PD Modification Application: MM 24-0674
Zoning Hearing Master Date: August 19, 2024
BOCC Land Use Meeting Date: October 8, 2024

Applicant: Abacus Farms, LLC
FLU Category: SMU-6 (Suburban Mixed Use – 6)
Service Area: Urban
Site Acreage: 6.23
Community Plan Area: Ruskin
Overlay: None

AGENCY REVIEW COMMENT SHEET

2.5 Proposed Site Plan (partial provided below for size and orientation purposes. See Section 8.2 for full site plan)

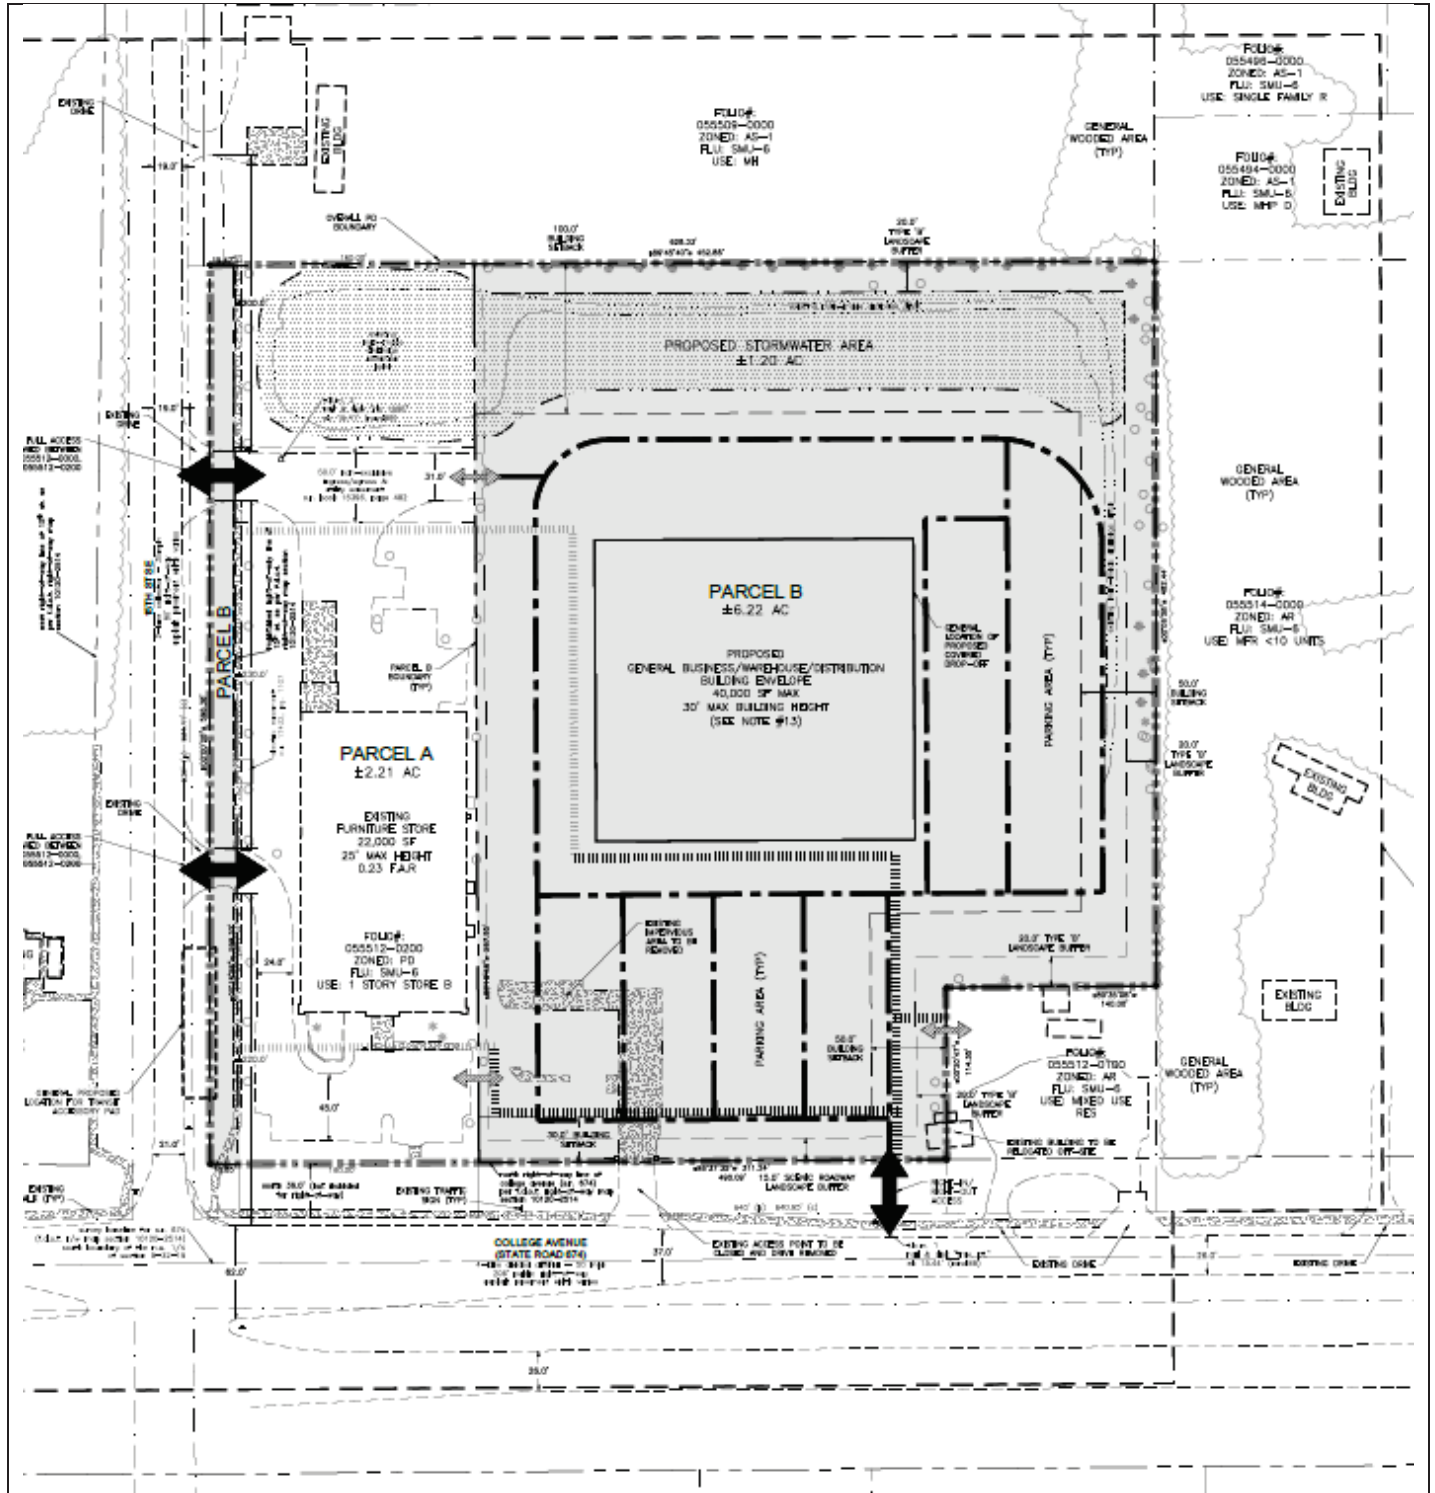
- 1. Revise the Label "Proposed General Business/Warehouse/Distribution Building Envelope" to Proposed Retail (Shopper's Goods)/Warehouse/Distribution Building Envelope".
